# Franklin County Planning Commission

### **Case ZON-13-03**

The applicant is requesting to amend an existing Select Commercial Planned District (SCPD) in order to expand an existing parking lot onto a currently undeveloped property. The proposal will not be detrimental to the surrounding area but does not fully comply with the recommendations of the Blendon Community Plan. Staff recommends *approval* with conditions.

DRAWING NO. DP1  
 SHEET 01

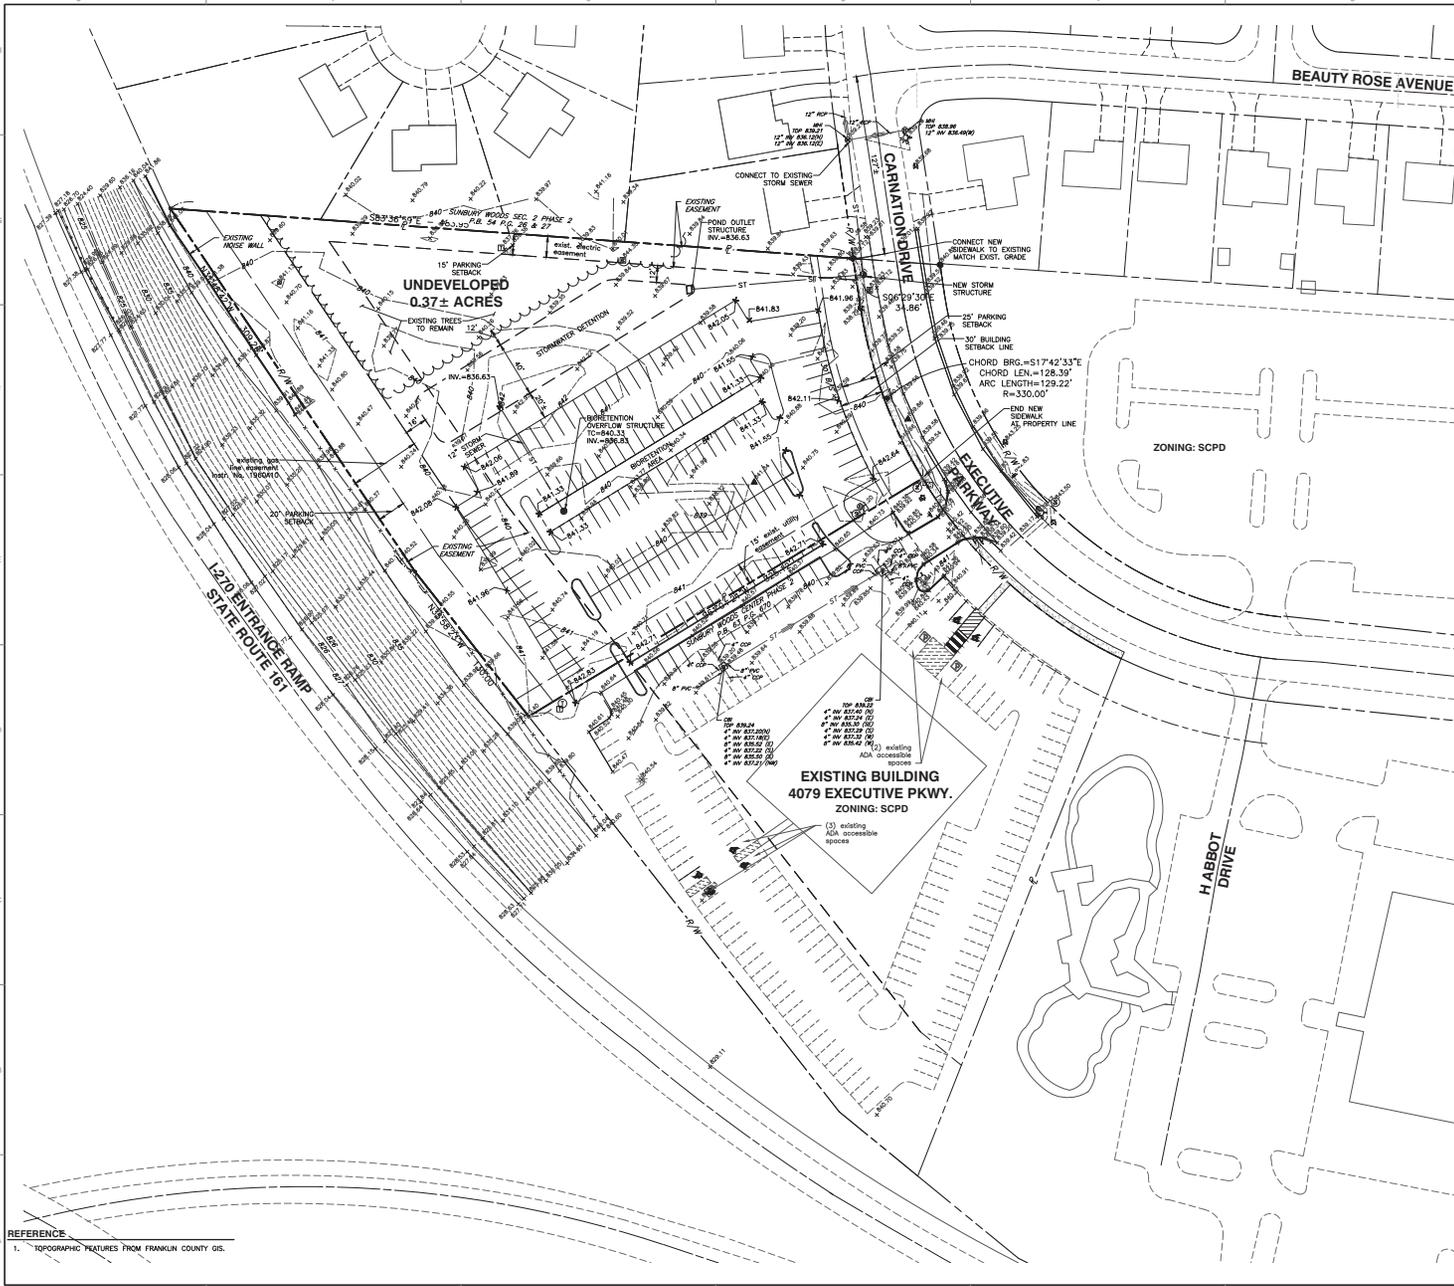
***The applicant has requested a waiver from the Smart Growth Overlay (SGO) maximum number of parking spaces.*** The SGO limits the number of parking spaces for office uses to one space per 300 square feet of gross floor area. Based on the 43,595 square foot building, the maximum parking allowed is 146 spaces. The applicant is proposing to provide 326 spaces. The Franklin County Engineer supports this request due to regular overflow problems along Executive Parkway as a result of insufficient parking.

***The applicant has requested a waiver from the General Development Standard for parking stall dimensions of 9'x18.'*** The applicant proposes to provide parking stalls with dimensions of 8'x16' in order to lessen the impact of providing parking in excess of the maximum required. The Franklin County Engineer's Office supports this request due to the need for additional parking in this area.

*The applicant has requested a waiver from the SGO parking lot landscaping standard.* Although the plan does not provide the required number of islands, it does provide the required number of trees and provides a greater area of landscaping than required by the Smart Growth Overlay. The proposed plan provides eight islands or peninsulas equal to approximately 4,000 square feet of landscaping and 19 trees.

As required by the Smart Growth Overlay, a sidewalk is proposed along Executive Parkway, extending the breadth of both of the subject parcels. The proposed sidewalk is 5 feet in width and is intended to connect with the adjacent sidewalks to the north. However, the site plan shows the adjacent sidewalk terminating prior to the dividing property line. A pedestrian walkway is also proposed to connect the sidewalk to the primary entrance of the building at 4079 Executive Parkway.

1. The applicant must apply for and receive an approved Certificate of Zoning Compliance from the Franklin County Economic Development and Planning Department prior to commencing any clearing or construction activities.
2. The applicant shall not clear any trees or vegetation on the site between May 15 and August 15 to prevent potential disturbance of roosting Indiana bats.
3. The applicant must execute a cross-access easement prior to Certificate of Zoning Compliance approval.
4. In keeping with the Blendon Community Plan, the applicant must place a conservation easement on the wooded area remaining undeveloped, protecting it from any future development in perpetuity.
5. The proposed sidewalk must connect to the existing adjacent sidewalk to the north.
6. The applicant must revise the development text to reflect both parcels subject to the rezoning request.
